# McMILLAN SAND FILTRATION SITE COMMUNITY CENTER & PARK

COMMISSION OF FINE ARTS STAFF REVIEW  
25 SEPTEMBER 2020

## MEETING AGENDA | SEPTEMBER 25, 2020

3.6 - RECREATION SPACE

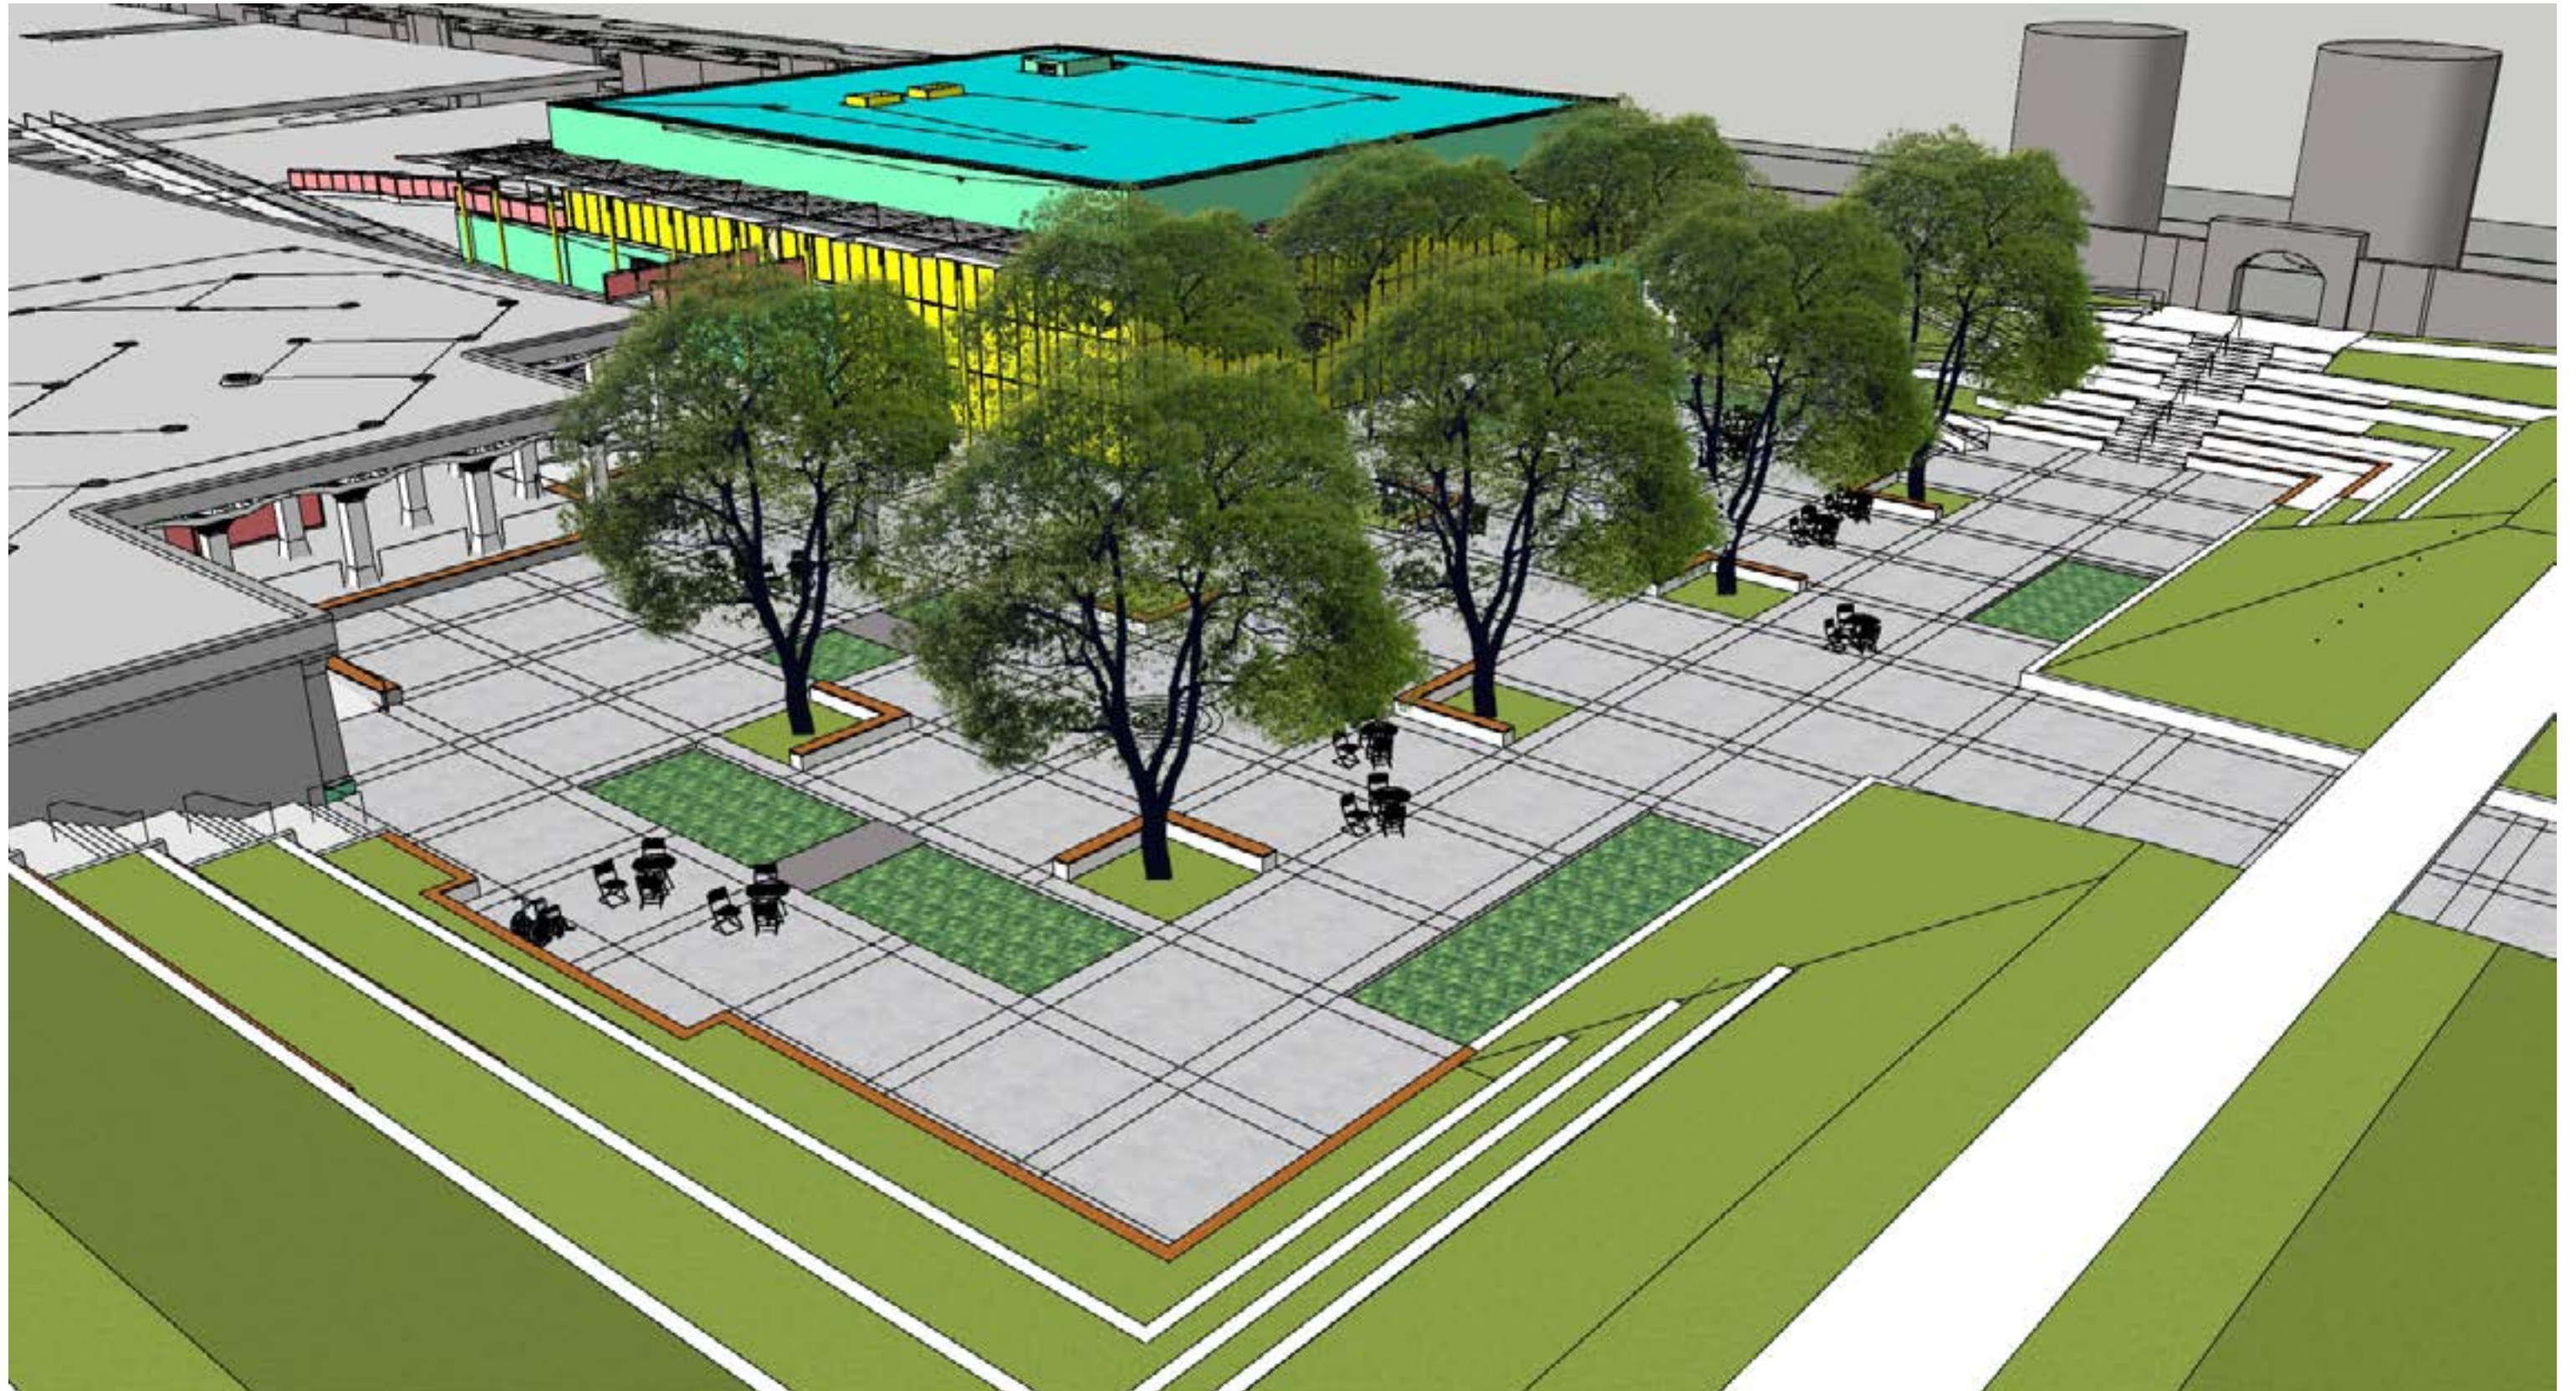
“[The Commission members] recommended repositioning the bioretention areas outward, possibly integrating them with the tree planting beds, and reducing the width of the outer walkway... they also suggested substituting moveable seating for the circular benches... they questioned the extensive use of concrete retaining walls and terracing that would support the earthen berm...”

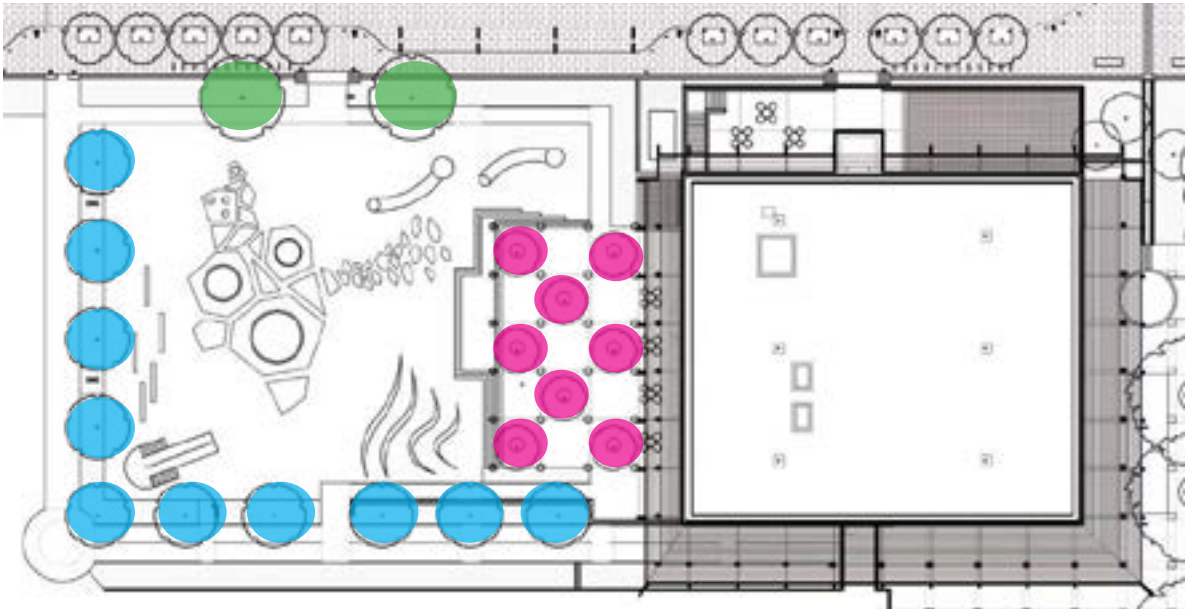
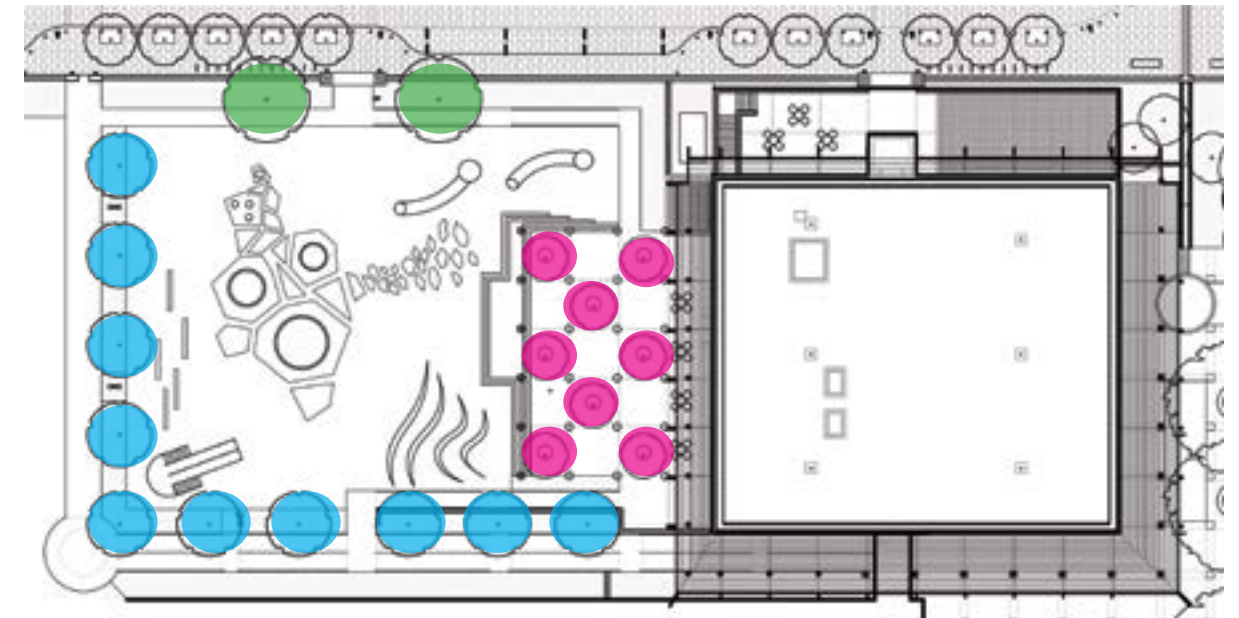
“[The Commission members] suggested the reconsideration of the proposed lindens in the playground, as these trees tend to attract bees; while this may be a desirable characteristic for promoting biodiversity, it may be inappropriate where children are playing”

“[The Commission members] suggested the reconsideration of the proposed lindens in the playground, as these trees tend to attract bees; while this may be a desirable characteristic for promoting biodiversity, it may be inappropriate where children are playing”

Response: Design team replaced proposed lindens with honey locust. The honey locust formerly proposed to enframe the playground have been changed to planetrees.

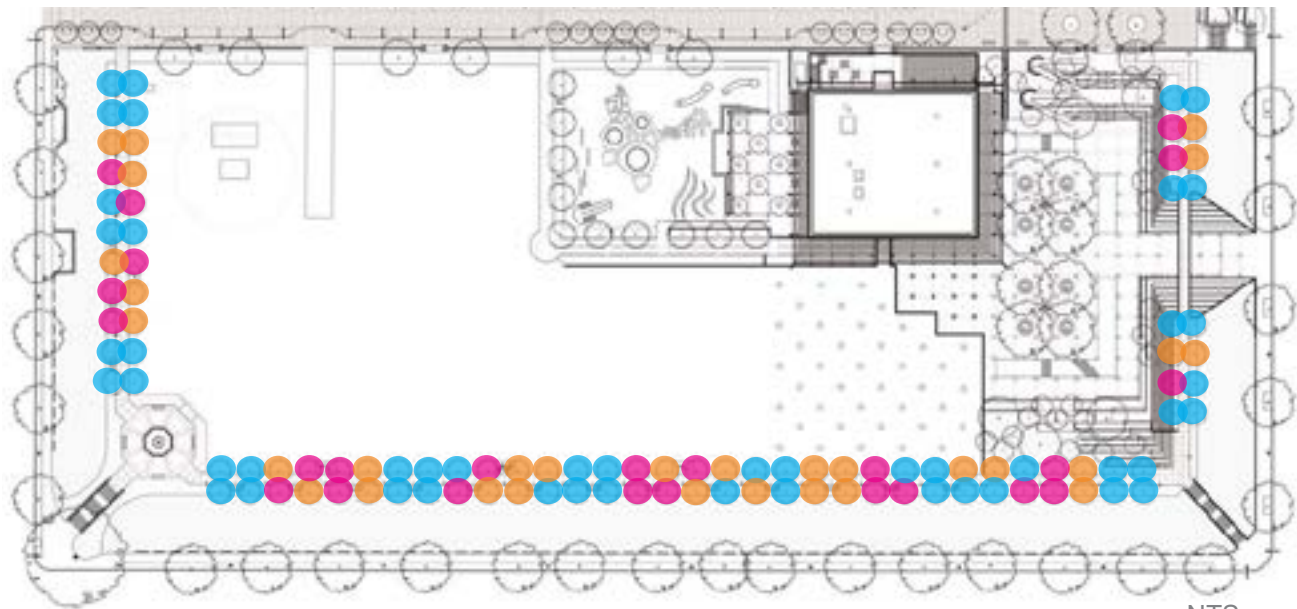
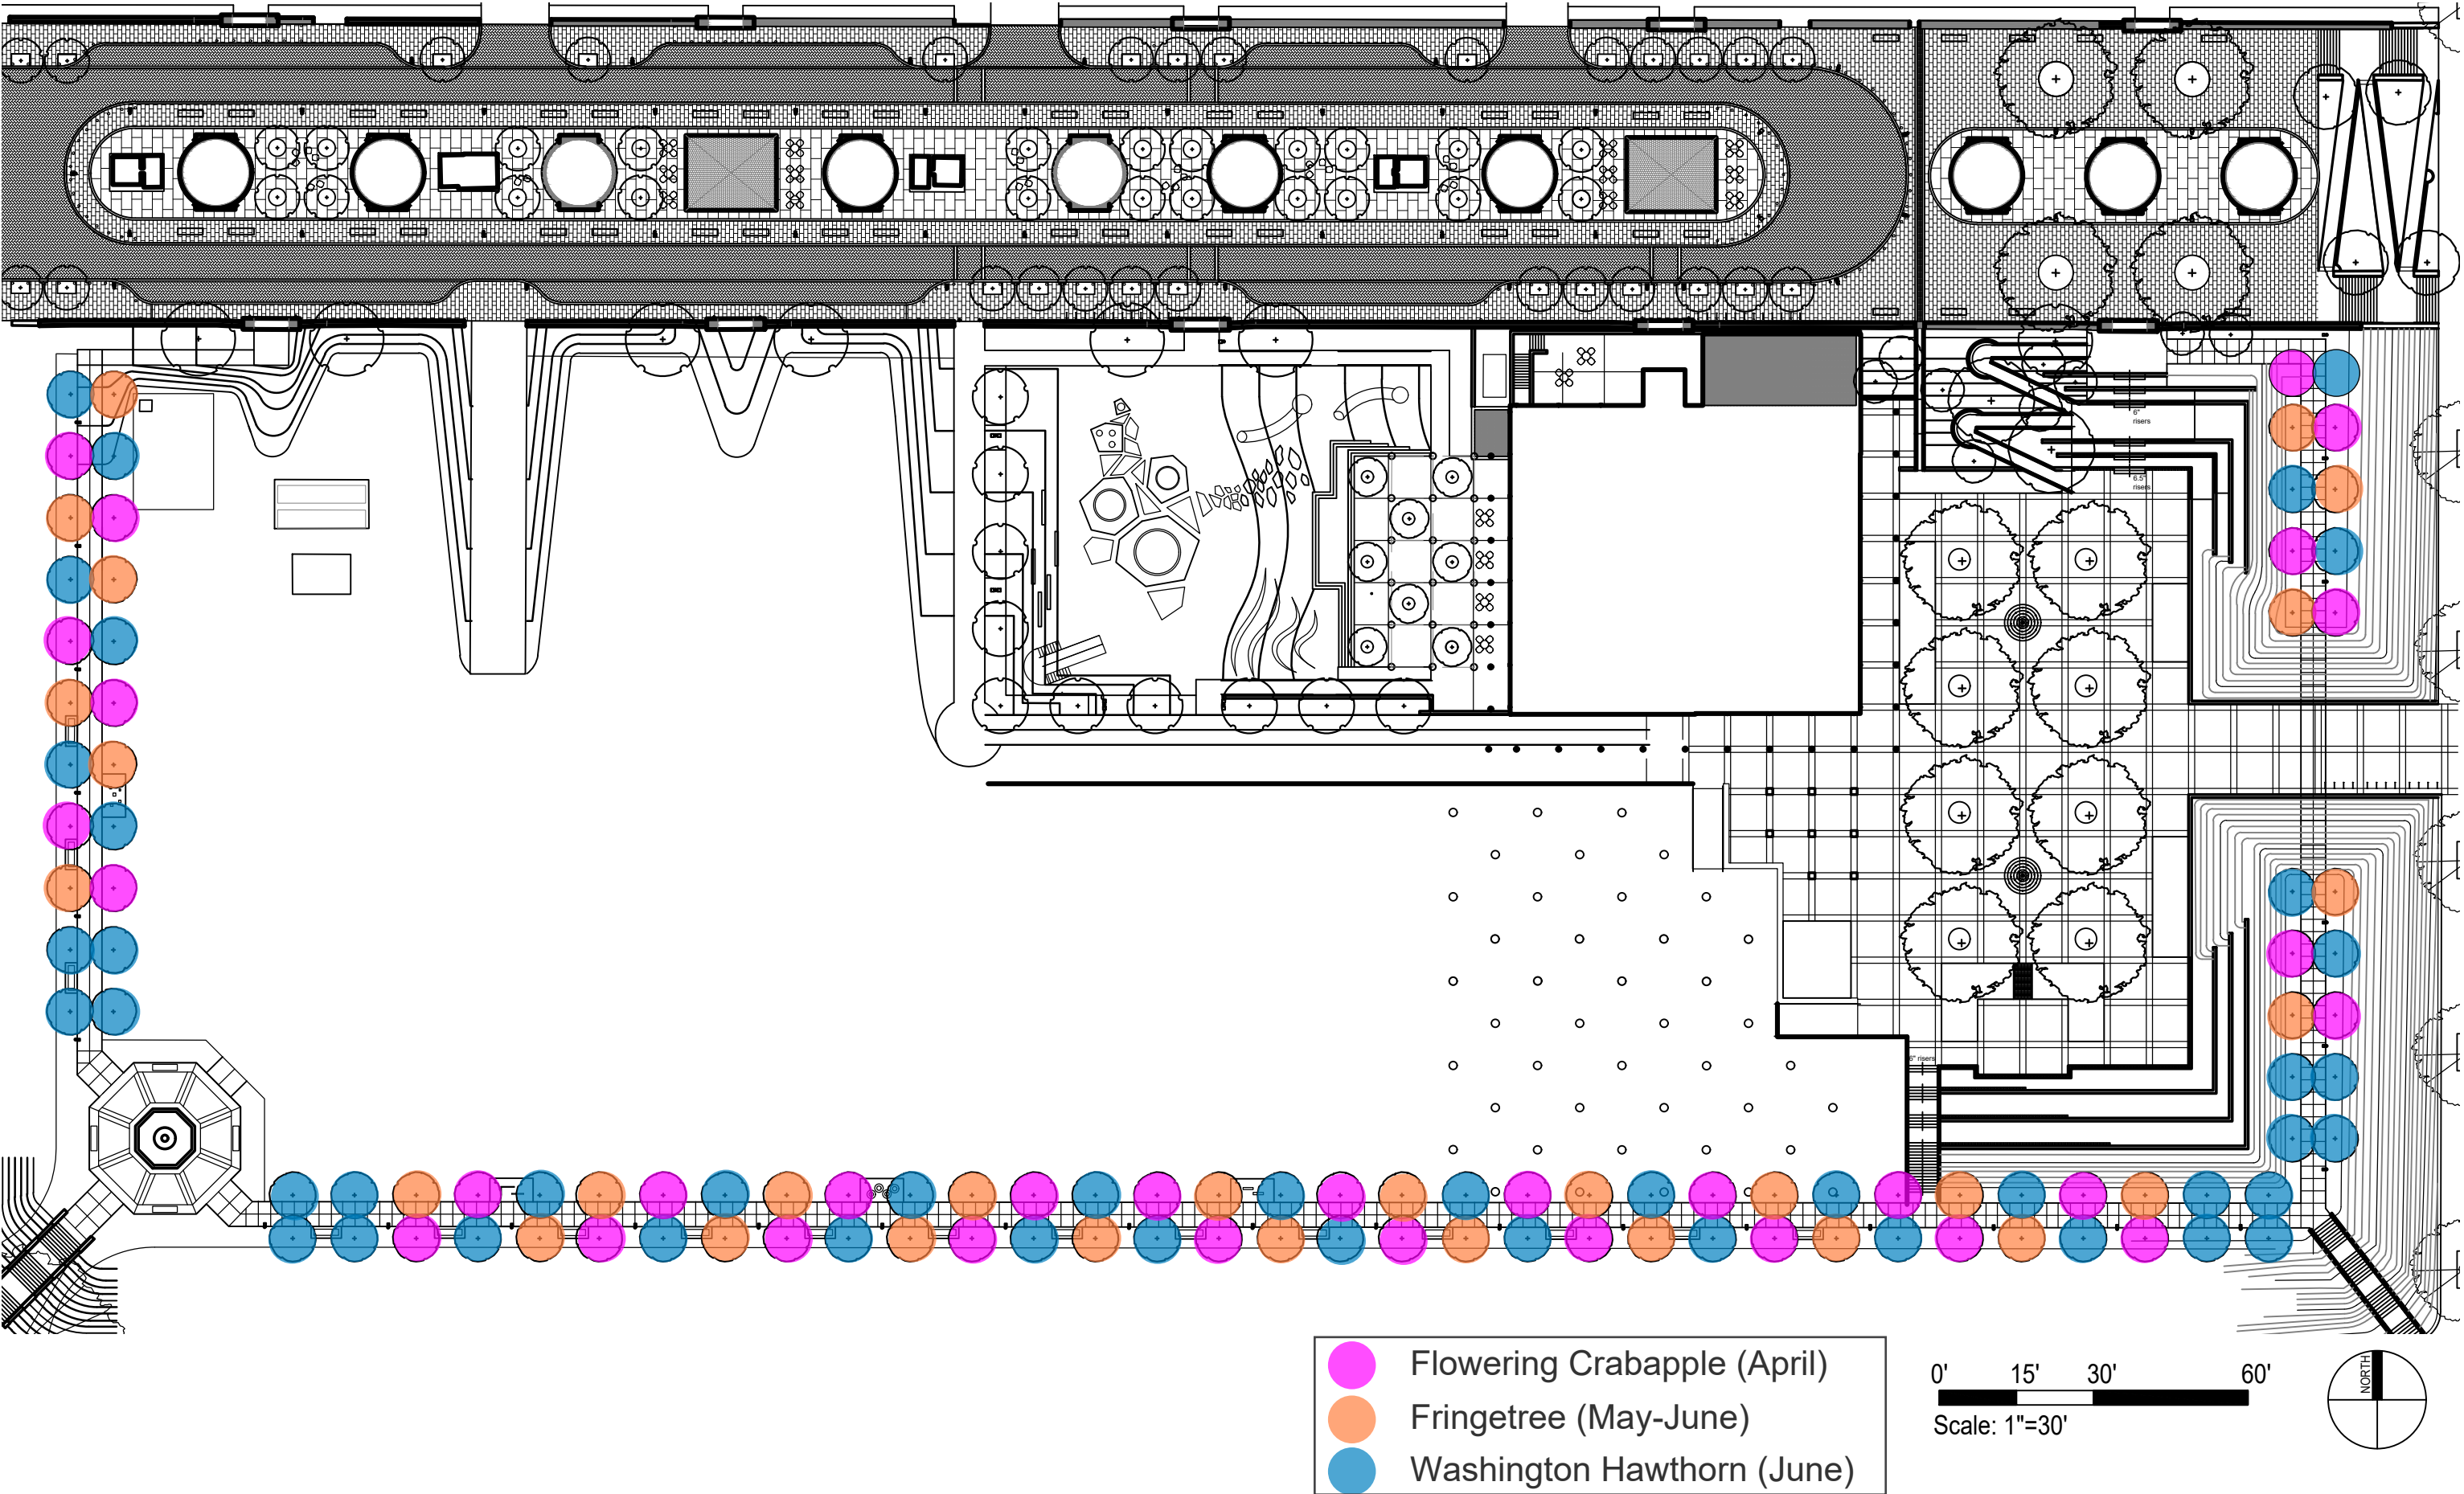
“[The Commission members] advised “further study of the blooming patterns of the various small trees proposed along the Olmsted Walk to ensure that the rhythm of colors appears intentional.”

The design team has further studied the layout of the three species of tree along the Olmsted Walk and has devised a more intentional rhythm. Pairs of hawthorn frame the entries to the Walk from the southwest and southeast corners while flowering crab and fringetree alternate, with attention paid to the flowering times of all three species in the overall layout.

OLMSTED WALK AND NORTH CAPITOL STREET ENTRY - ENLARGED SITE PLAN

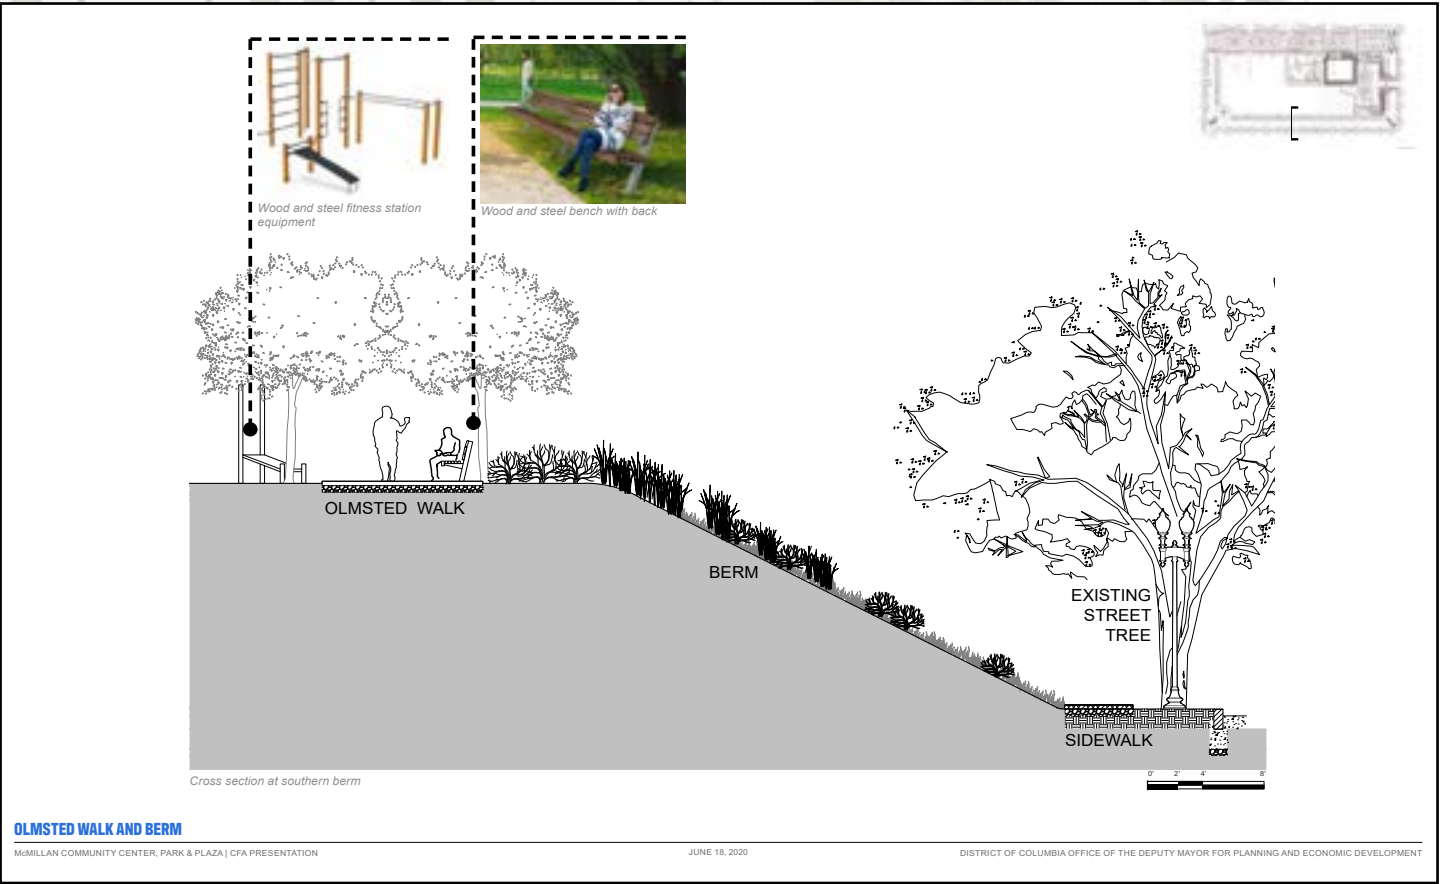
“[The Commission members] recommended further study of the placement of the proposed exercise stations along the walk, commenting that using them may be challenging due to their close proximity to the narrow path”

“[The Commission members] recommended further study of the placement of the proposed exercise stations along the walk, commenting that using them may be challenging due to their close proximity to the narrow path”

Response: Design team is working closely with DPR on the selection of appropriate fitness equipment as well as on the preferred dimensions of the fitness areas with respect to the Olmsted Walk.
